July XX, 2021
Olympus reference: QIL 154-007

URGENT FIELD SAFETY NOTICE

NOTIFICATION ABOUT SOFTWARE UPDATE FOR CV-1500 AND RESUMPTION OF USE WITH EZ1500 SERIES ENDOSCOPES

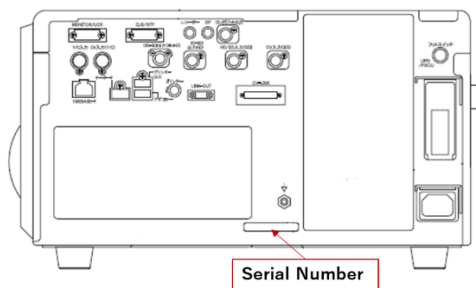
1. Carefully read the content of this Field Safety Notice as well as the **Attachment 1 “Important Information – Please Read Before Use ■Precautions for illumination light emitted from the endoscope’s distal end”**
2. Ensure all personnel are completely knowledgeable and thoroughly trained on the content of this FSN and the referenced attachment and append the **Attachment 1** to the existing IFU of the EZ1500 series endoscopes.
3. Inspect all CV-1500 devices in your possession and identify their serial numbers. The serial number can be found on the back of device as illustrated in the following picture.
